Objection letter to Peak Ranch Resource Application M2020041; Request for Party Status

Re: Opposition to Peak Ranch Resource Mining Application M2020041
and Request for Party Status

RE: Peak Ranch Resource – 112 Mining Reclamation Permit Application (File No. M2020041)

Figure 1. Example of vegetation zones that develop on a reclaimed lake shore with varying gentle to steep slopes. Shorelines with healthy littoral and riparian zones provide many benefits to wildlife and to water quality. (from MDNR 2012)

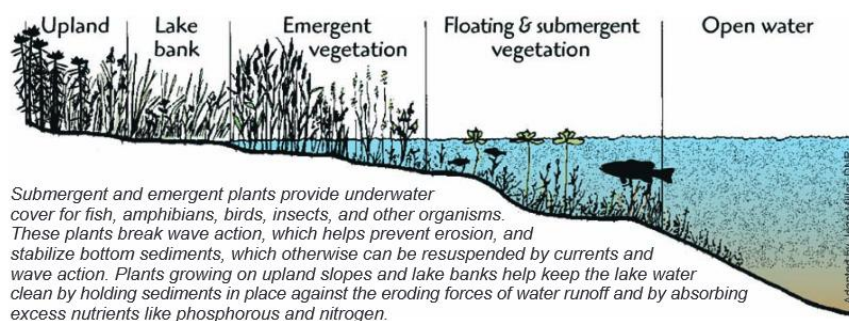
The applicant proposes to minimize its reclamation obligations by “reclaiming” half of the disturbance area to “a groundwater lake for the benefit of local wildlife.” (Exhibit E, p. E-1) In reality, the pond, as designed (Exhibit C – Pre-Mining and Mining Plan Maps, Map C-2B), will have little or no public value.

As planned, the shoreline of this pond is starkly uniform. The entire pond will be enclosed by steep 3H:1V mined slopes both above and below the water line. (Exhibit F – Final Reclamation Plan, Map F-1) This design will accommodate only extremely narrow zones suitable for emergent and bank vegetation. Physical diversity, in this case variable and gentler slopes, is necessary to promote desirable vegetation growth and encourage greater connectivity with the existing riparian vegetation along the Blue River and thus provide real benefit to local wildlife. (Figure 1, below)

The permit application includes a further deficiency: in addition to uniform slopes, the pond perimeter is nearly rectangular, broken up by a perfunctory bit of decorative “scalloping” along the northeast corner. Rule 6.3.4(1)(d) plainly requires that where “wildlife habitat is the proposed future land use, shorelines should be irregularly shaped to promote a diverse wildlife habitat.”

Recommendations: If a “reclaimed” pond is a component of an approved permit application, it should be redesigned to ensure it provides public benefit: for wildlife and/or recreation. A regrading plan should be developed and implemented that will result in varying shoreline slopes,

both above and below the waterline, and promote shoreline vegetation that will provide habitat for insects, fish, amphibians, and birds. The applicant should be further encouraged to take this opportunity to redesign the perimeter of the pond to be more irregularly shaped from its current poorly disguised rectangle.

Figure 2. Potential wetland resources located on the PRR property.

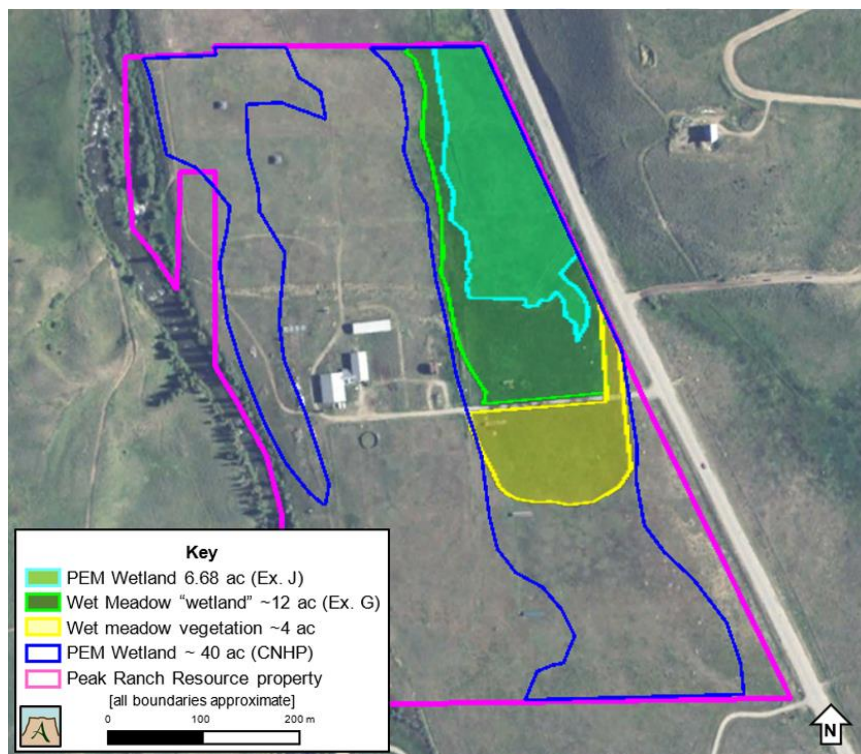
In contrast, in Exhibit G – Water Information, a larger proportion of the Rocky Mountain Alpine-Montane Wet Meadow vegetation community is characterized as “wetland area” (Figure 2, below). No additional information is provided as to how this approximately 12-acre wet meadow “wetland” was determined.

In aerial imagery, as well as on the ground, the wet meadow vegetation can be observed to extend further south than indicated even in Exhibit G, increasing the potential for wetland resources on site to exceed 16-acres (Figure 2, below). Additional resources indicate that historical wetlands may have covered at least 40-acres of this property. (CNHP 2020; see also Figure 2, below)

Depending on the full extent of jurisdictional wetlands found on this property, the areal extent of wetland resources that will be directly impacted by the proposed mine, haul road, and berms ranges from less than 0.1-acres to over 10-acres.

Recommendations: It is imperative that the actual extent of the wetlands on the property is independently confirmed by the US Army Corps of Engineers before this application can be deemed complete and adequate. The applicant also needs to revise and complete Exhibit J and provide DRMS and other interested parties all of the Wetland Determination Data Forms used in the wetland delineation described therein.

Figure 3
Hillyard Property
Lower Blue River
Measured Wells

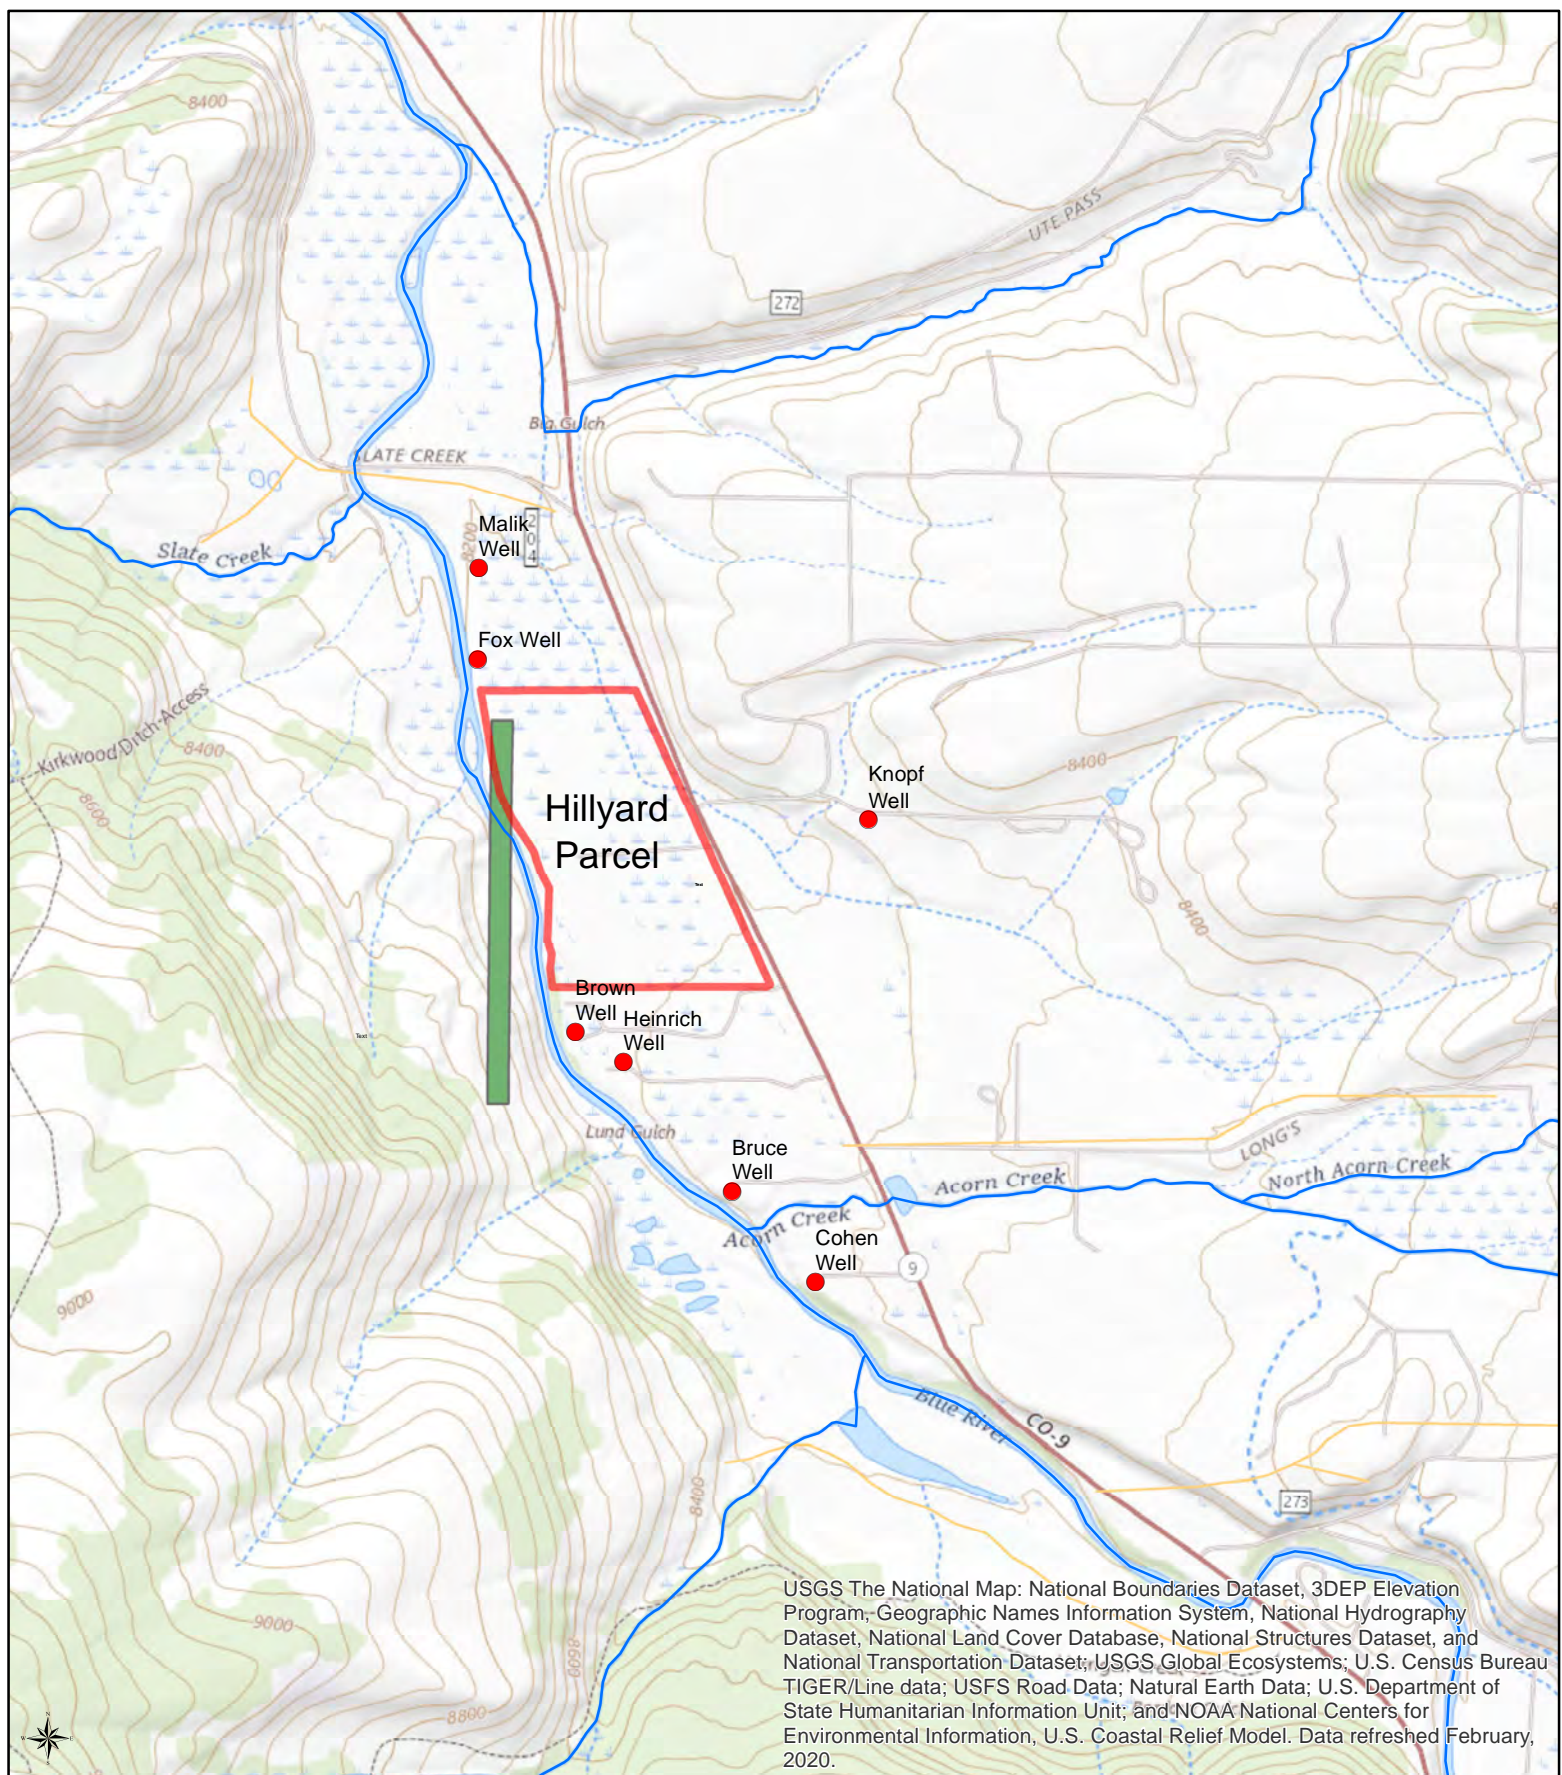
There is high groundwater in the area underlying the Hillyard Property. Groundwater levels in nearby wells were measured at various times in 2019 and 2020. The depths to groundwater are shown in Table 1, attached. The locations of the wells in which water levels were measured are shown in Figure 3.

The average elevation of the water table measured by the applicant in wells located on the Hillyard Property from the Peak Ranch Resource Application information is 8,211 feet above mean sea level. The highest average water level for the water measurement data from the application is 8,215 feet above mean sea level. (These water level elevations were determined based upon the water level measurements in Exhibit G and the pre-mining land surface elevations shown in Figure C-1

Figure 4a
General Aquifer Characteristics

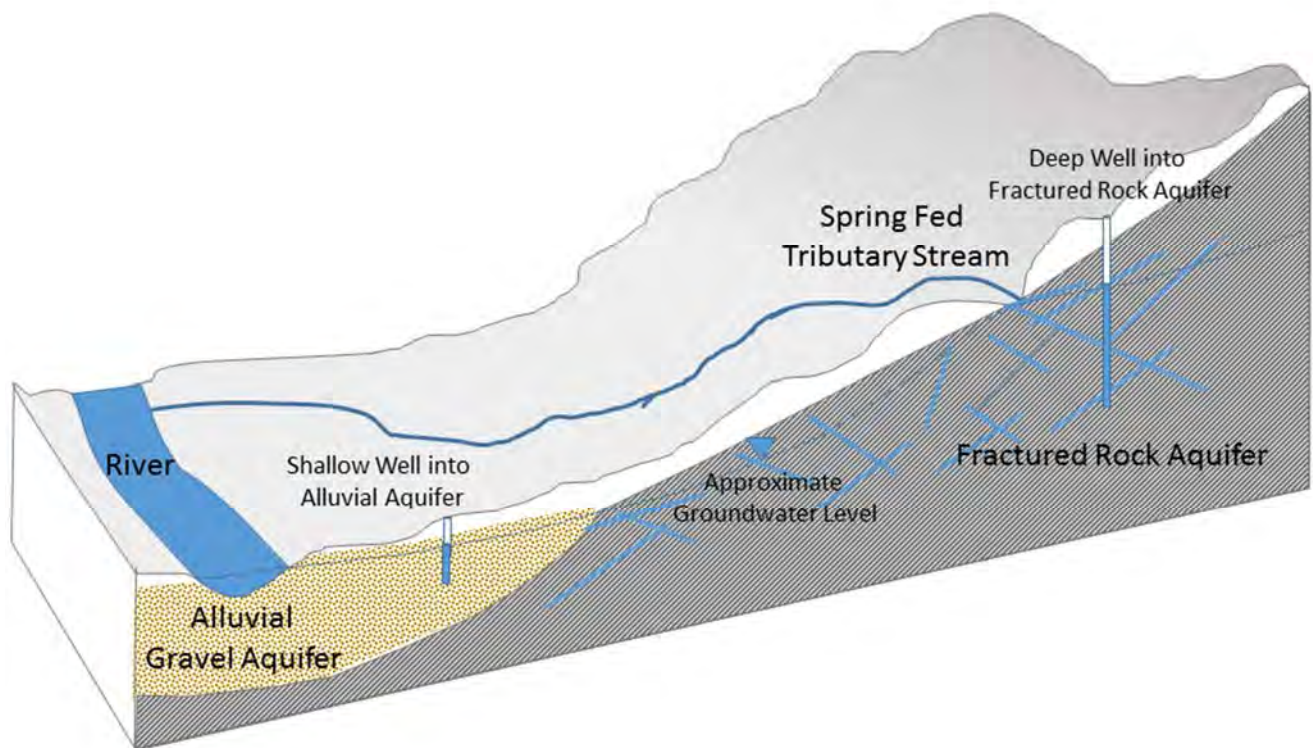
From our research of geological features in the area, it appears that the uphill aquifer is a fractured rock system, with flow paths that can quickly move water out of the fractured rock system to the gravel alluvial aquifer in the valley below. A general schematic depicting the aquifer characteristics in the area is attached as Figure 4a. Figure 4b demonstrates a potential gravel pit in the area.

Figure 4b
General Aquifer Characteristics Showing Gravel Pit (Wet Mining)

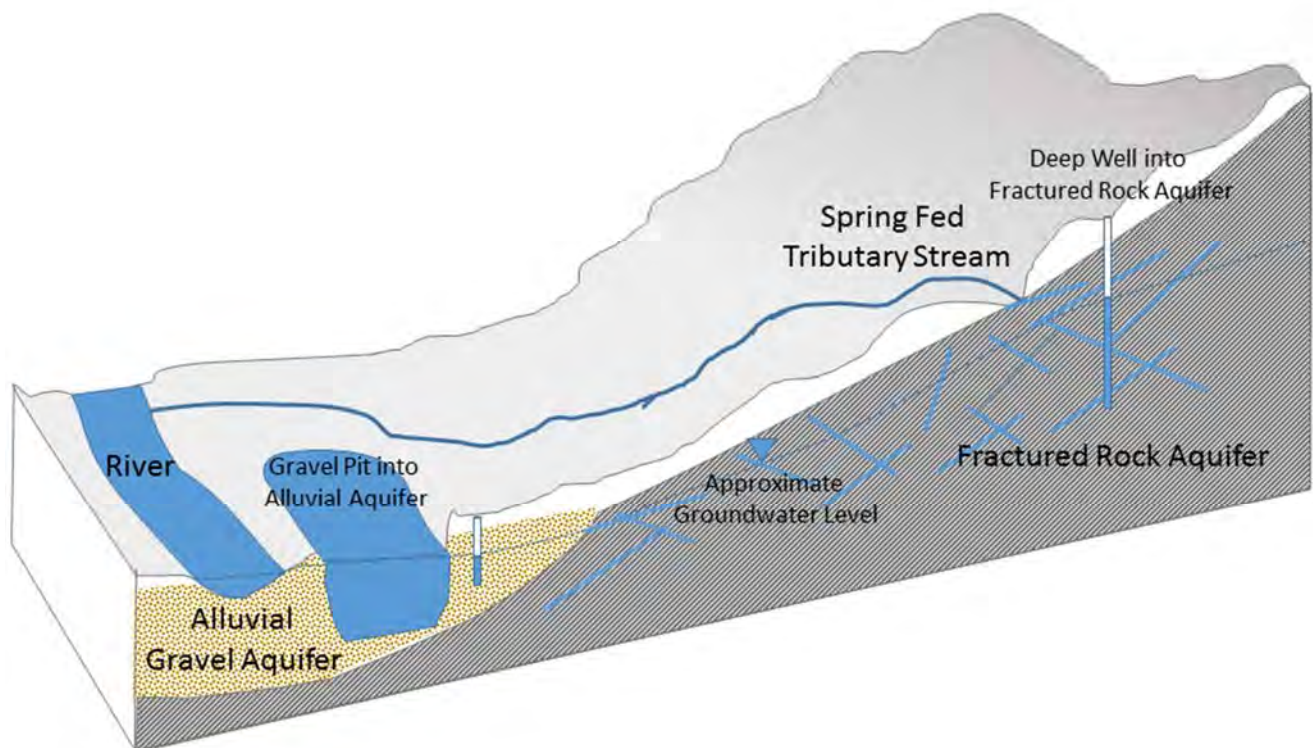
There is the potential for the mining at the Hillyard Property to create issues for the well owners in the area. The applicants plan to mine using a wet mining operation, where the gravel pit is mined without dewatering the pit. This type of operation can cause impacts to the water levels in nearby wells. These impacts would likely impact wells upgradient of the mine more severely, due to the pit causing more water to flow out of the local aquifer into the pit. In most gravels the pore space is approximately 20% of the gravel. If this is the case in the area, the mining operation could draw 5 times the amount of water out of the local groundwater system, than occurs currently on the parcel.
